Consultation Response regarding the NTCTN Cycle Track between Tsuen Wan Bayview Garden and So Kwun Wat

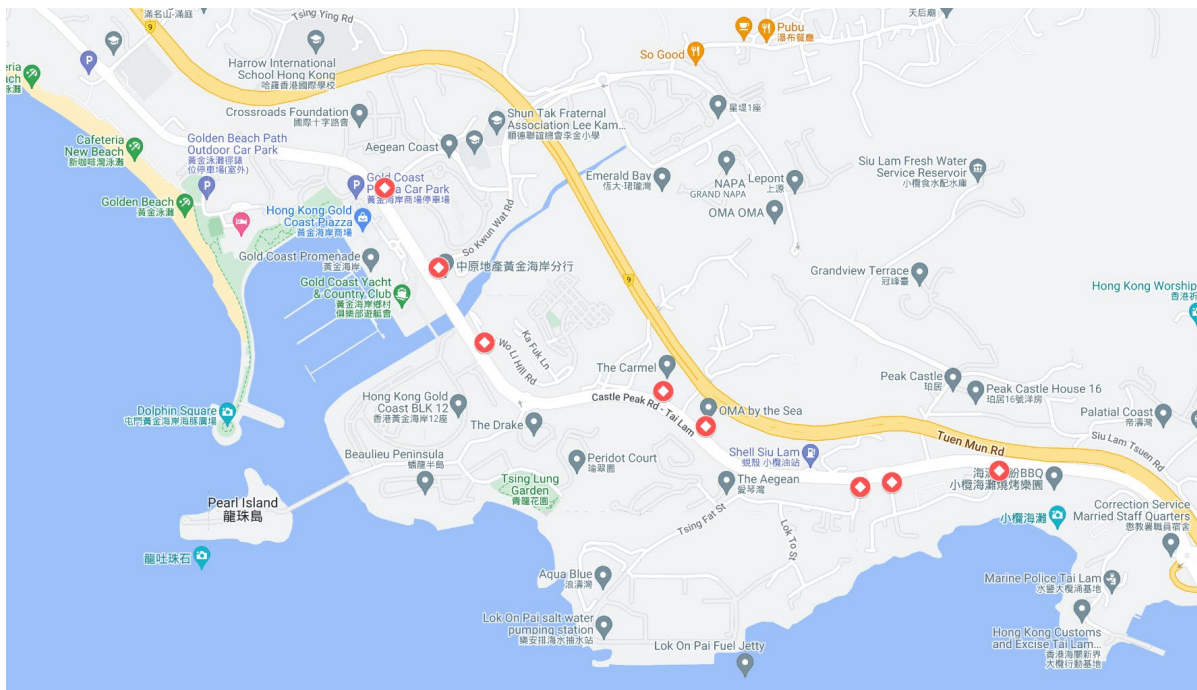
- Two residential access near Bay Bridge Lifestyle retreat (as marked by red arrows below)

Junction between Castle Peak Rd - New Ting Kau and Castle Peak Road - Ting Ka

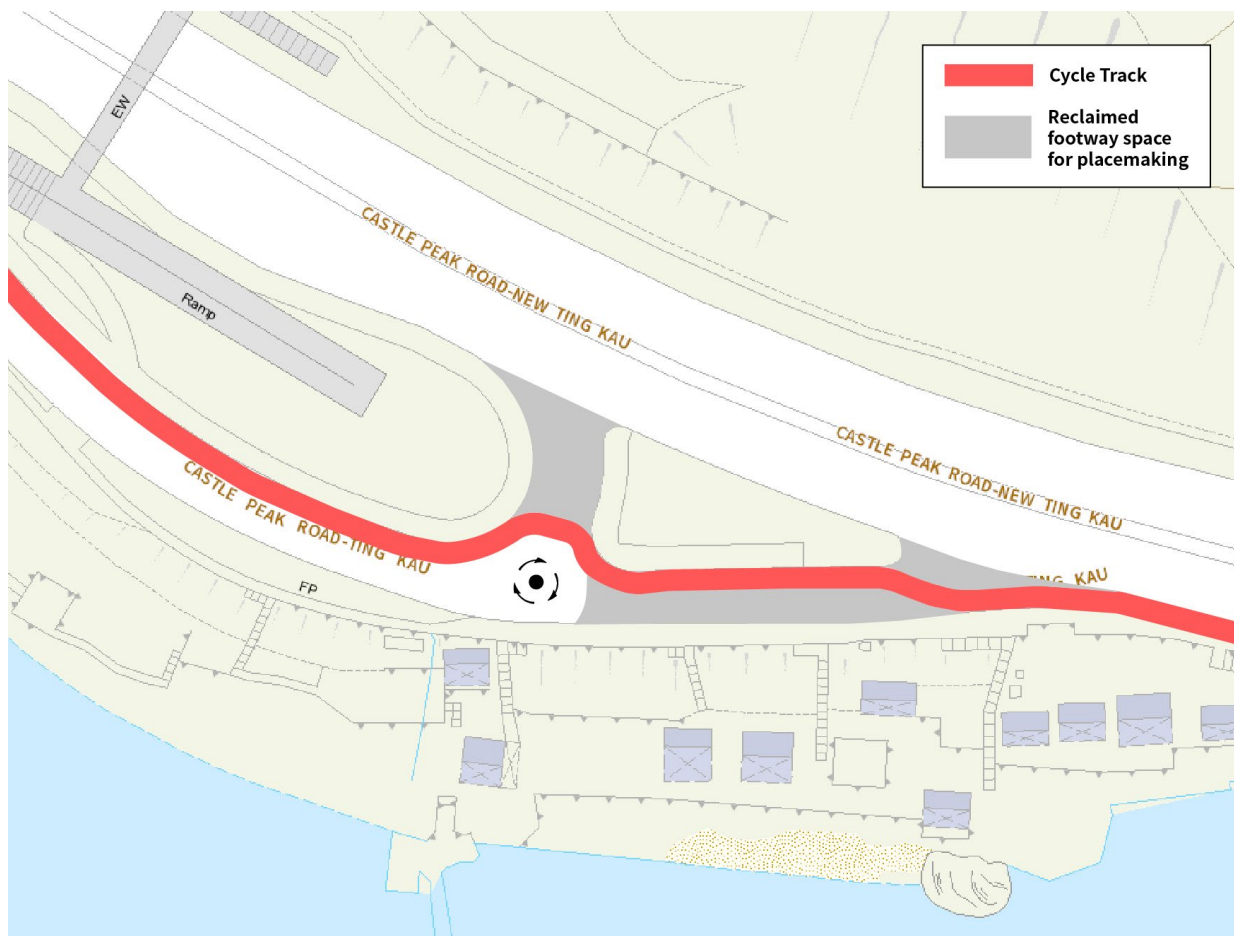
- 4.8 We are particularly concerned about the junction arrangement at the Castle Peak Rd - New Ting Kau & Castle Peak Road - Ting Kau (shown in the green arrow below). The existing alignment shown in public consultation appears to be using the existing uncontrolled crossing locations as cycle track crossings, using the central reservation and continuing the journey up west aside from the pedestrian footbridge. Our humble advice is that this arrangement, if it is exactly what we thought it would be, is deemed to be a very dangerous arrangement.

- 4.9 We think that the existing arrangement of uncontrolled crossing is already flawed, where the major arm (Ting Kau/ New Ting Kau) has a speed limit of 70 kmh with the minor arm speed limit being 50 kmh, the location of the existing crossing is too close to the junction. Be it 70 kmh or 50 kmh, drivers approaching from major arm to minor arm would not have had sufficient distance or time to react to hazards and stop (stopping sight distance; SSD) calculation suggests 50kmh traffic speed would have required at least 134m of stopping sight distance). Crossing these two ingress/ egress junctions safely would have been very difficult without any sort of signalised controlled crossings, as suggested in paragraph 4.3 with the quoted crossing selection diagram. Our concern remains that there is no sufficient clearance from the major arm to place the crossing with the existing crossing locations.

- 4.10 One of the options is to push back the crossing location further to the west, say immediately west of the existing footbridge, as circled in red in the figure below. This provides sufficient clearance from the junction for traffic to acclimatise to the local speed limit. But picking up the alignment next to the New Ting Kau section would have anticipated a topological challenge.

- 4.11 Another more ambitious option would be to close off the eastern access of the Ting Kau section (both ingress and egress). The road typologies have suggested that the eastern access has little significance as it only provides access to the Westbound on New Ting Kau section. For any traffic going east traffic, they would have to go to the roundabout next to the Ting Kau Car Park anyway for going eastbound on New Ting Kau Section.
